Foothill Street Solar Project

MEMORANDUM

TO: Planning Board, Town of Yorktown
From: Edward Kolisz, Fire Inspector
Re: **Foothill St. Solar Farm**
Date: October 29, 2021

Re: Response to Outside Consultant Environmental Review Comment Letter
Con Edison Clean Energy Businesses, Inc.
Yorktown A Solar Project
3849 Foothill Street
Yorktown, New York
2478.001.001

C002

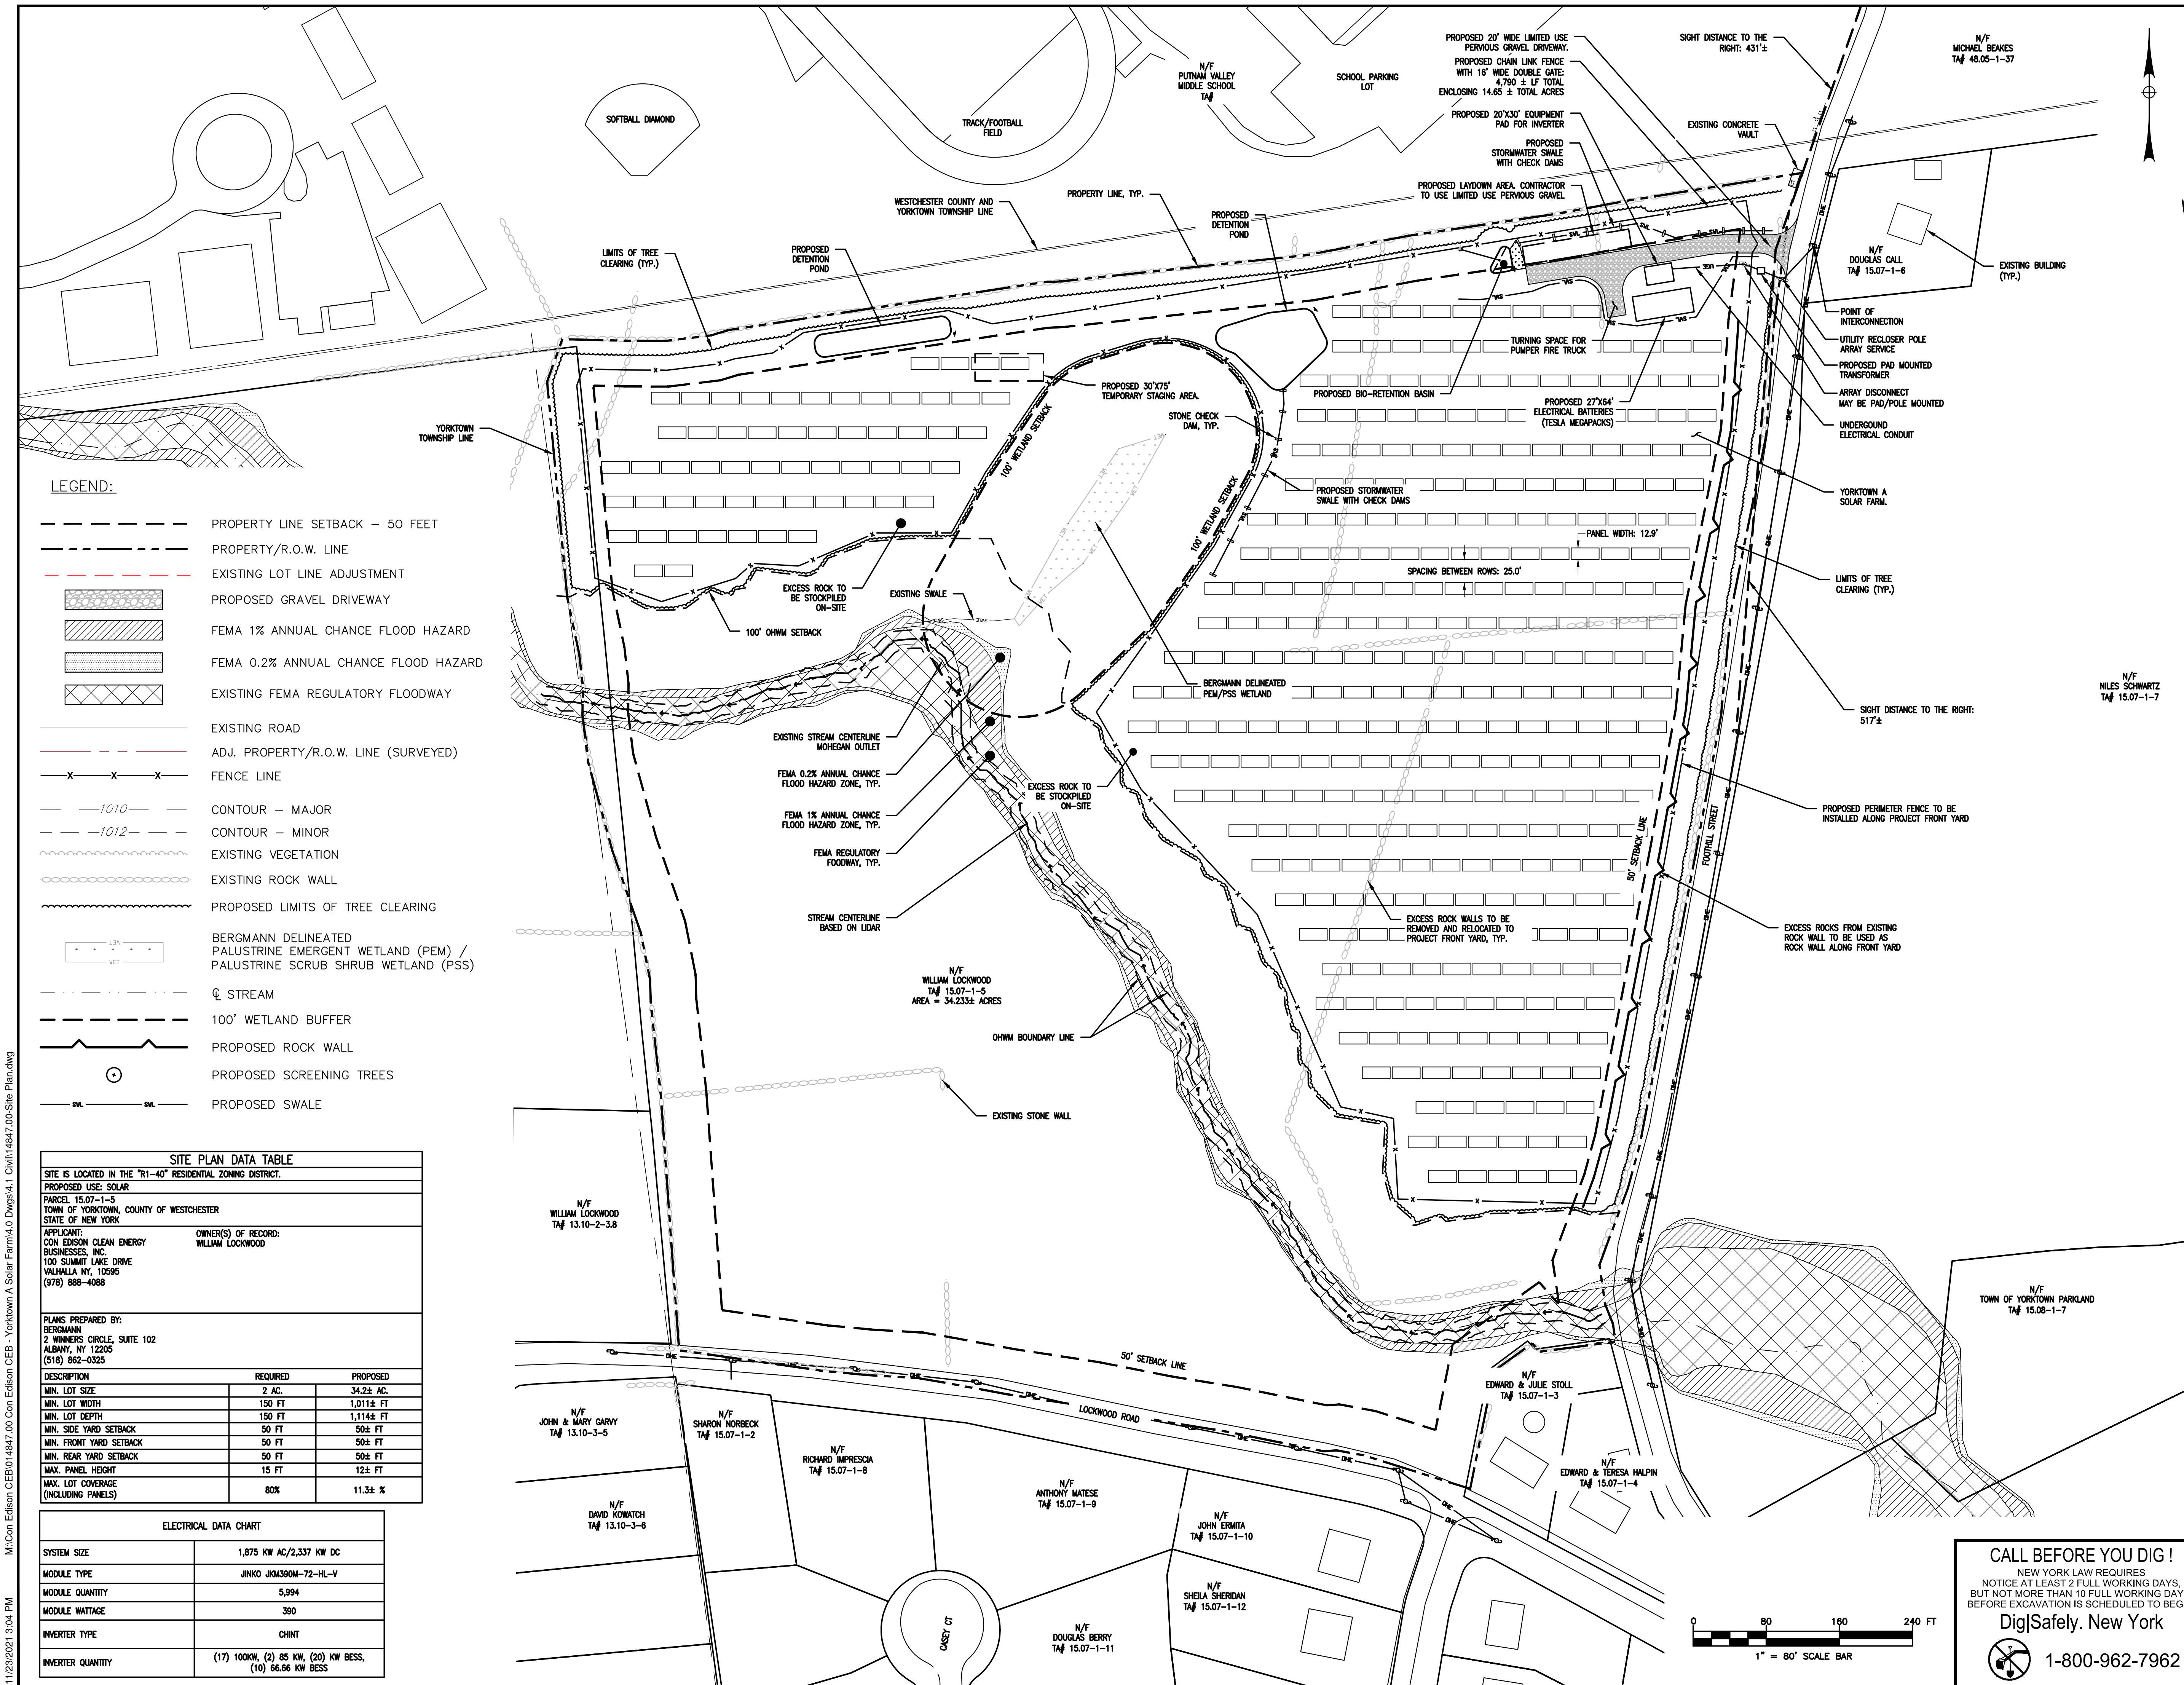
An electrical data chart has been added to sheet C002 to show the electrical data pertaining to the proposed system. The numbers shown on the electrical data chart represent the entire project site.

An electrical data chart has been added to sheet C002 to show the electrical data pertaining to the proposed system. The numbers shown on the electrical data chart represent the entire project site.

FILTREXX FILTERSOXX SEDIMENT CONTROL
NO SCALE

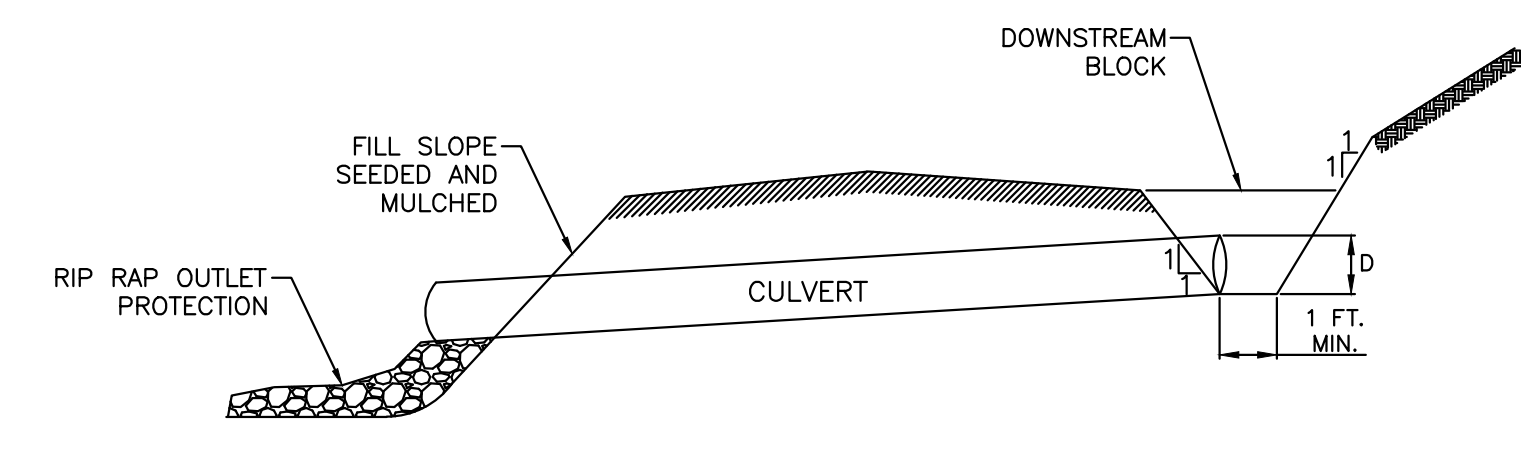
8. Replace silt fence with compost filter sock.

Noted. All silt fence on site has been replaced by silt socks. A compost filter sock detail has been added to sheet C009 of the site plans.

SOLAR PANEL INSTALLATION WITH LEVEL SPREADERS
N.T.S.

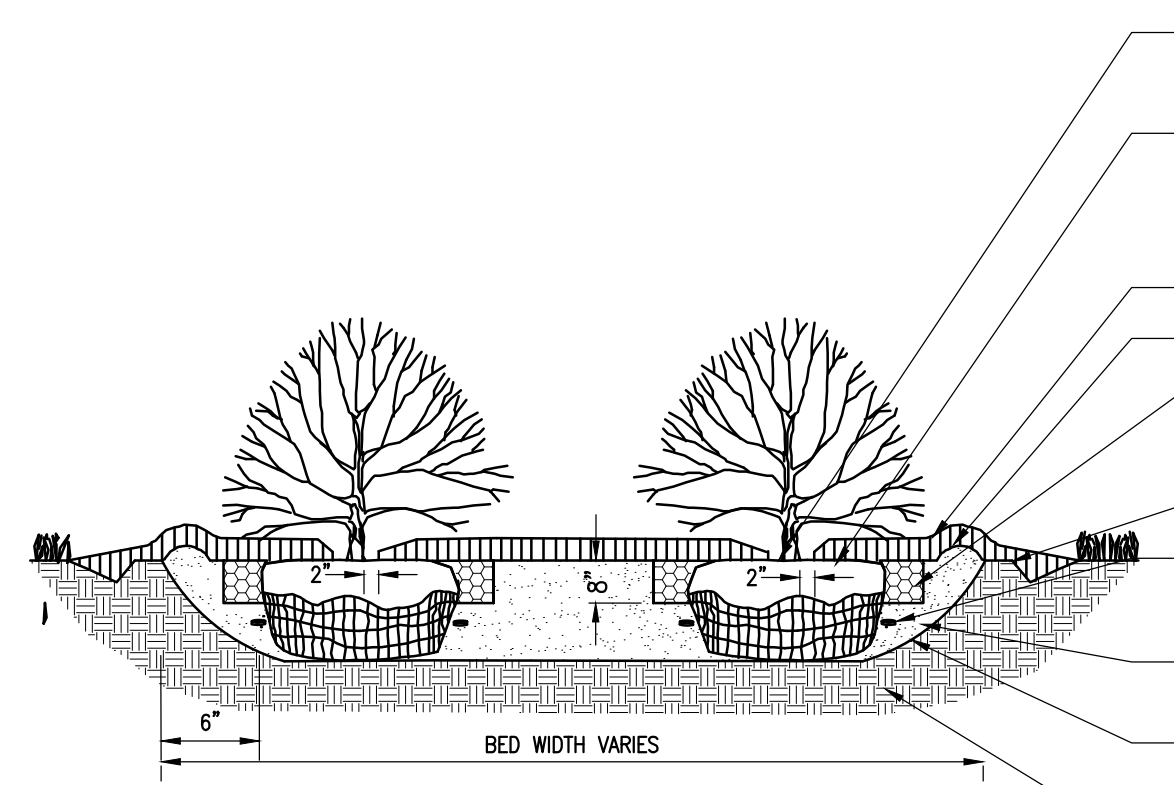
3. Item D.2.e (Project Operations) – Please ensure that the solar panels can be considered a pervious surface by complying with the requirements as stated in the New York State Department of Environmental Conservation Memorandum titled ‘Solar Panel Construction Stormwater Permitting/SWPPP Guidance’ dated February 21, 2020. Large amounts of surface runoff are not being capture on site before being discharged into streams and wetlands. The amount of runoff is changing due to replacing forested area with grassy fields. In order to comply with the above stated requirements, the change in surface cover must be accounted for such that hydrology will not change between pre and post development conditions. If the panels cannot be considered pervious, adjust these numbers and design accordingly.

The solar panels are considered a pervious surface as they comply with the requirements in the NYSDEC Memorandum referenced above. Flow spreaders have been added at the dripline downstream of the panels on slopes greater than 5 percent. Please refer to the updated Site Plans included as an attachment to this letter.

C013

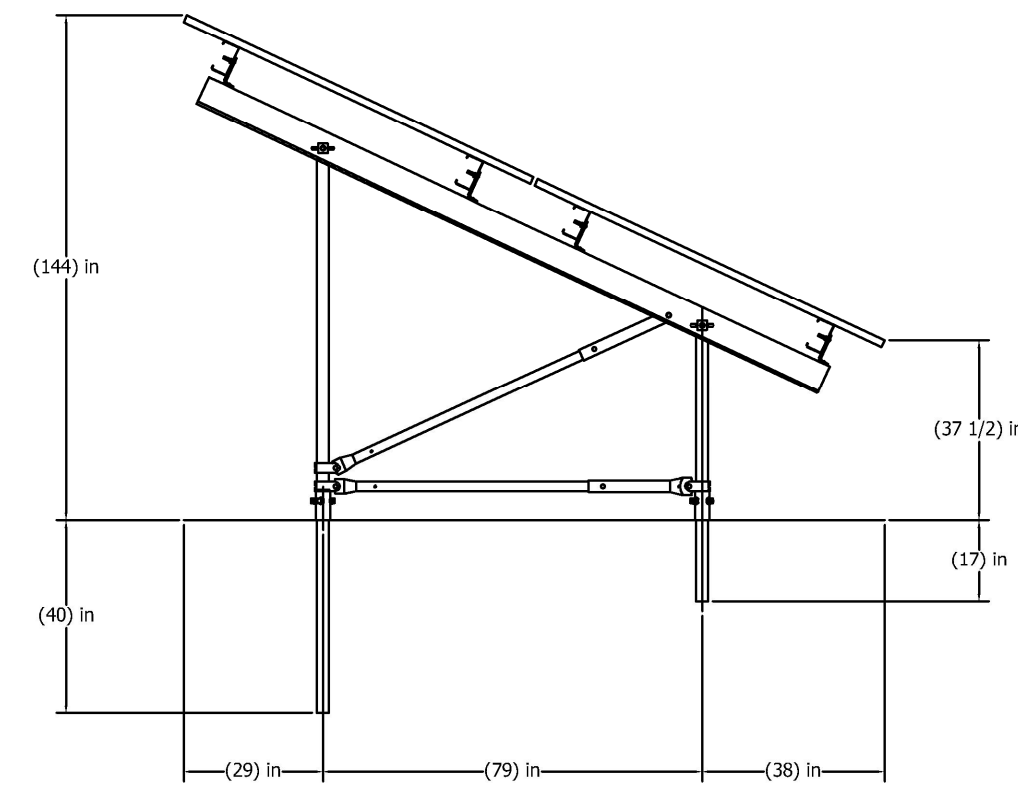
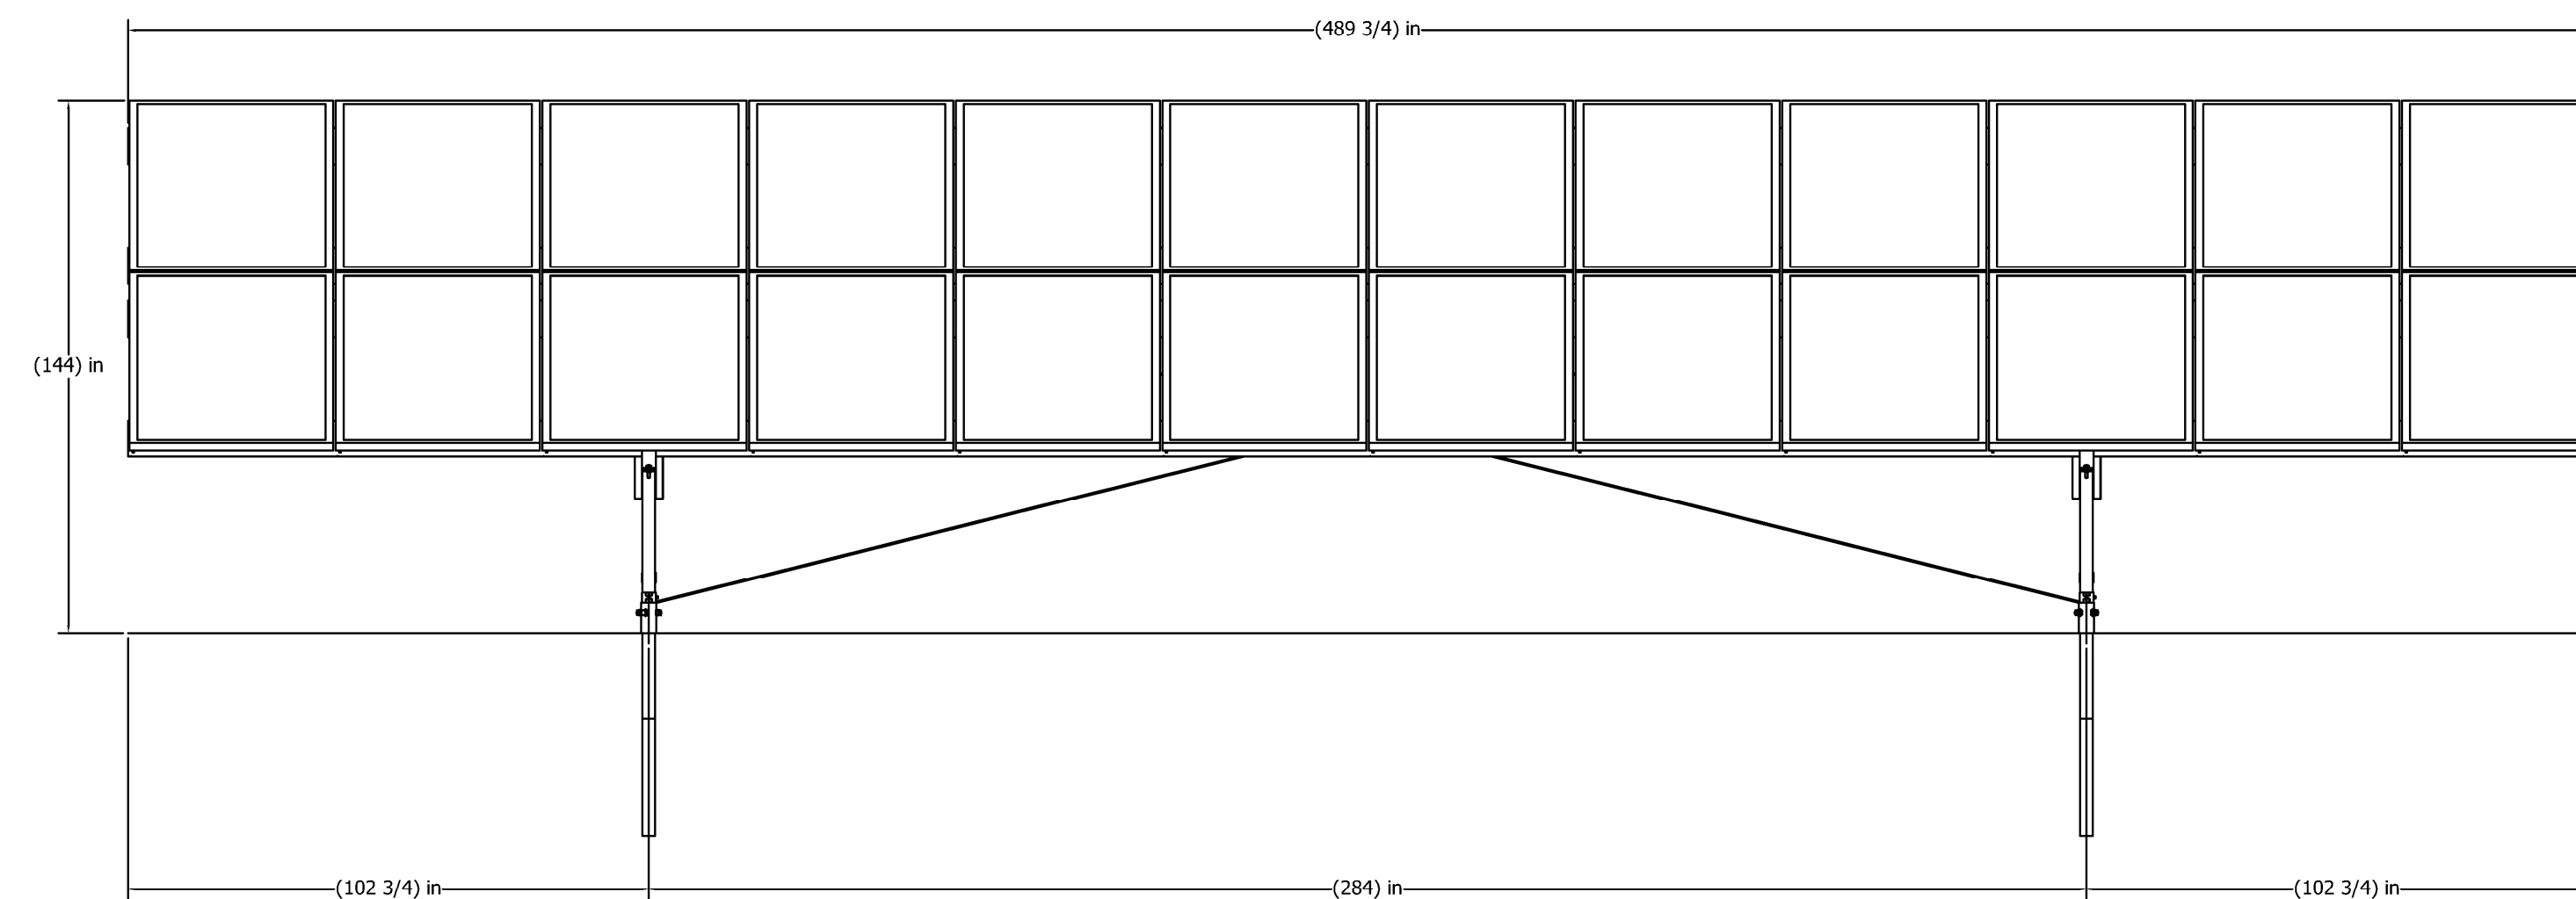
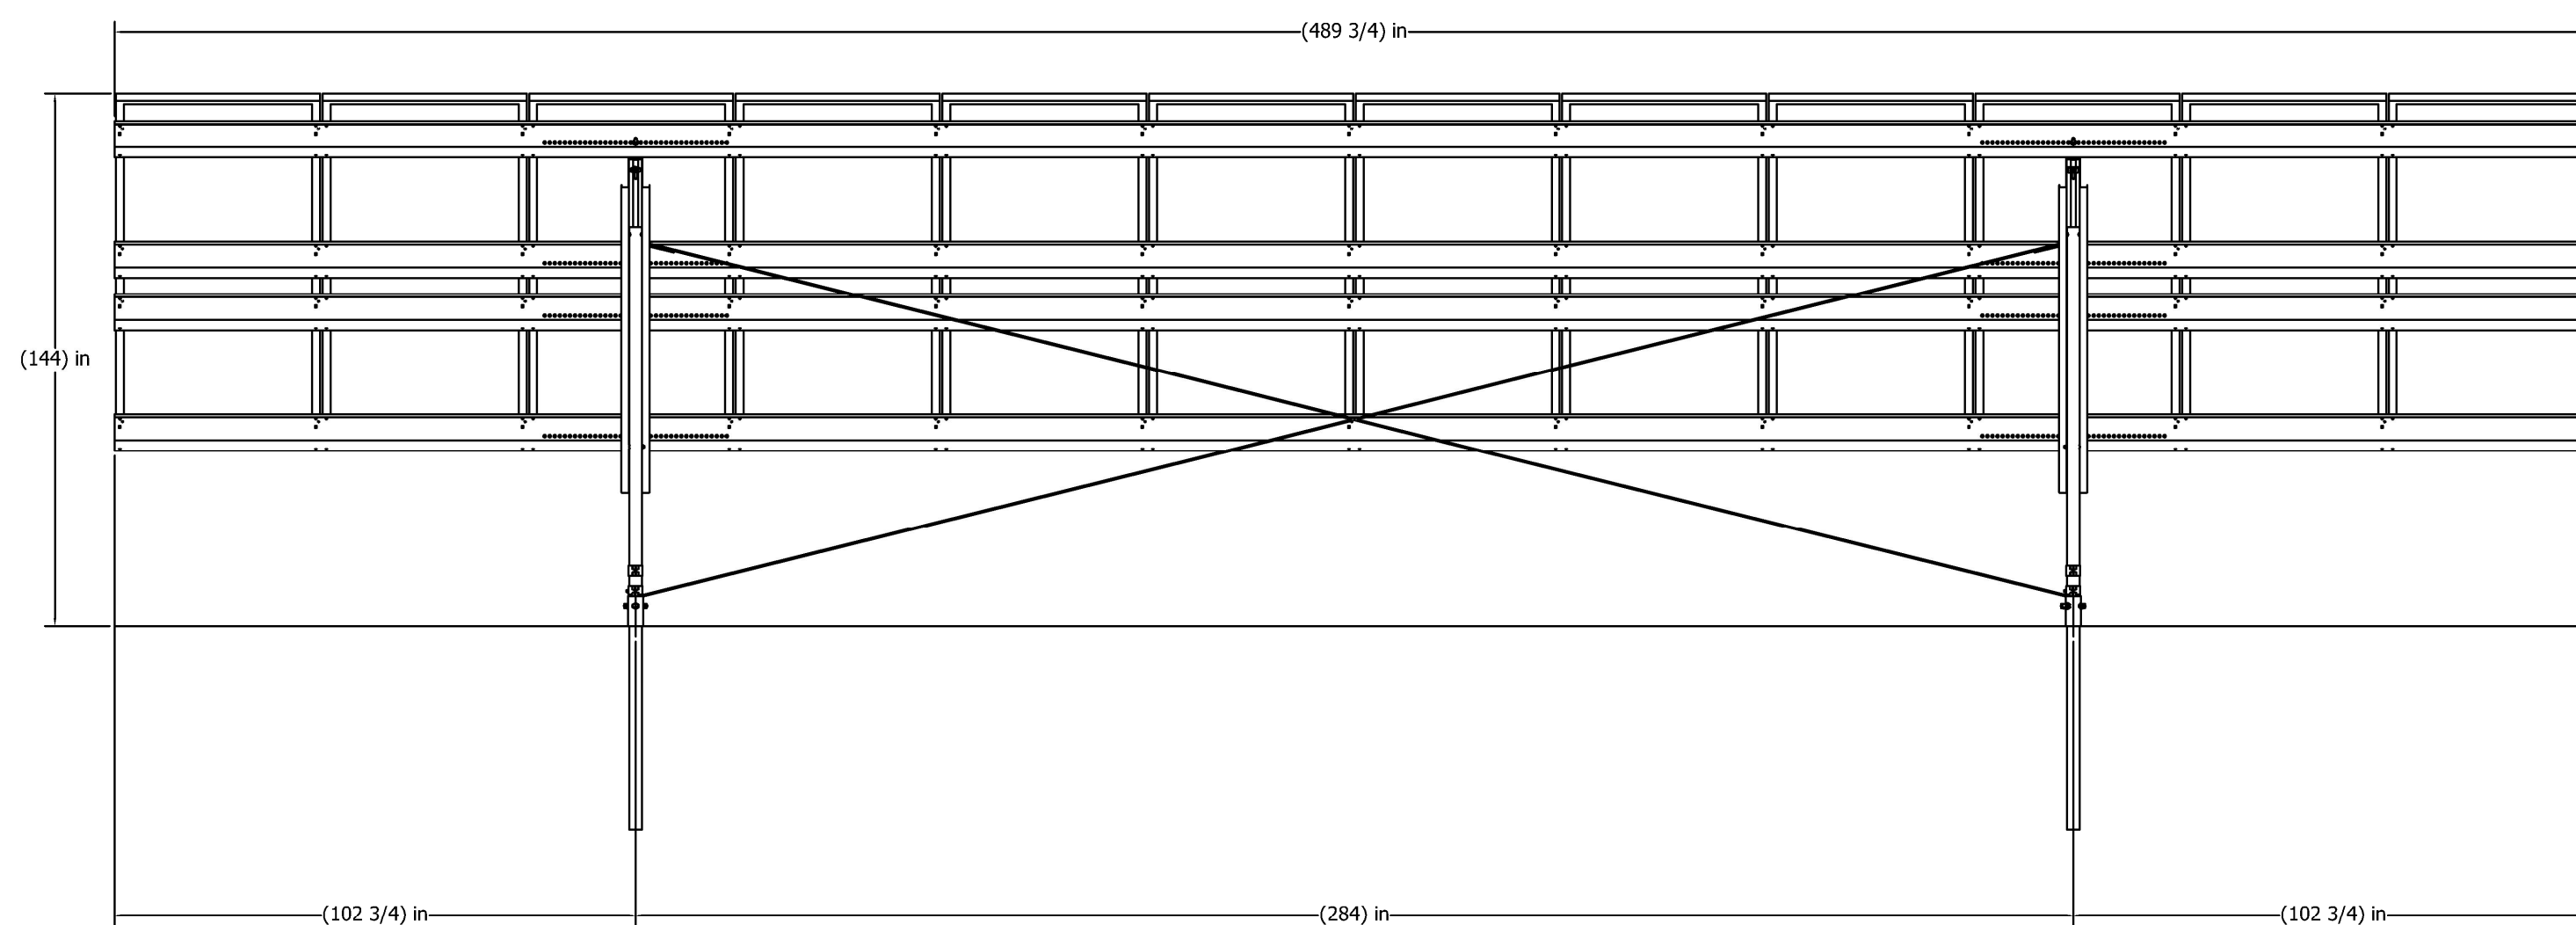
4. Page 2 – The letter states that the maximum height of the panels will be 12 feet. This information is not stated anywhere else. Please ensure this number is accurate, and if so, please present on plans.

Typical panel details have been added to the site plans. Refer to sheet C013 of the site plans. More specifically, the panels are 3' off of the ground at their lowest end and no higher than 12' off the ground at their highest point.
